07-024A 7 December 2007

#### CHANGES TO THE TELEDYNE API IN-HOUSE OZONE GENERATOR TEST FIXTURE

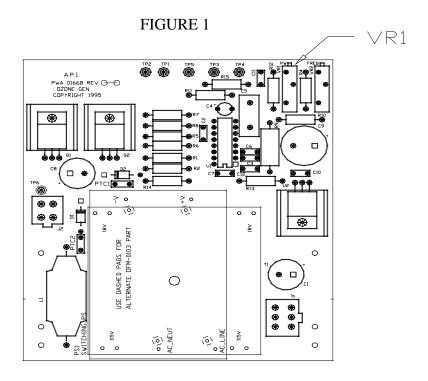
- This note is to inform Teledyne API's customers of the changes that Teledyne API has implemented to the In-House Ozone Generator Test Fixture.
- Previously, ozone generators were tested by adjusting the VR1 potentiometer while monitoring the voltage between TP4 and TP5 of the ozone generator driver board.
- They have since removed the Power Supply from the driver boards and have added a 0.1 load resistor to each of the power cables going to the ozone

- generator. The control voltage is still adjusted using VR1 and is measured across on TP4 and TP5.
- The ozone generator test procedure has been updated to reflect these changes to the test fixture.
- This was implemented in mid June 2007 starting with Model M200E S/N 1921.

Adjust VR1 located on the ozone generator driver board clockwise two (2) full turns. Refer to FIGURE 1 below for the VR1 location. VR1 may also be called PW on some boards.
